Project #22-012 Cytiva Expansion Located at 1725 South Hyclone Road

Project Name: Cytiva Expansion

Request: Design Review & Conditional Use Permit

Submitted By: Russ Holley, Senior Planner

Figure 2 shows the proposed building height of 80'

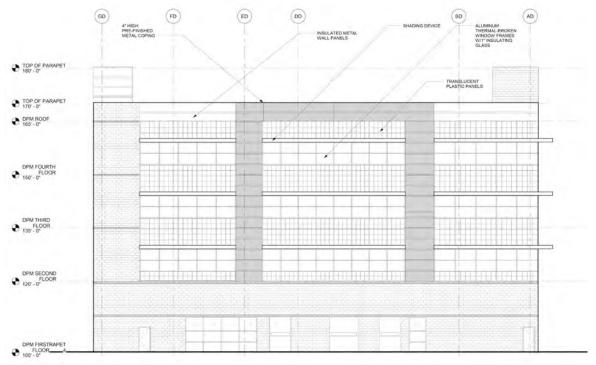
The IP zone has a standard building height maximum of 48'. A Conditional Use Permit allows a building height increase of up to 80'. Their proposal is for an 80-foot-tall building as measured from the top of the parapet. Conditional Use Permits are reviewed and approved by the Logan City Planning Commission in accordance with the LDC Section 17.42. Conditional Use Permits give the land use authority and opportunity to appropriately mitigate any unique adverse impacts created by the land use and specific proposal. Section 17.42.05 states:

Considering the context of the site, the proposed larger setbacks, building design and adjacent property character, staff finds that the increased height will not conflict with the above approval criteria as submitted.

- 1. All standard conditions of approval will be recorded with the Design Review and are available in the Community Development Department.
- 2. The Conditional Use Permit authorizes the 80-foot-tall building.
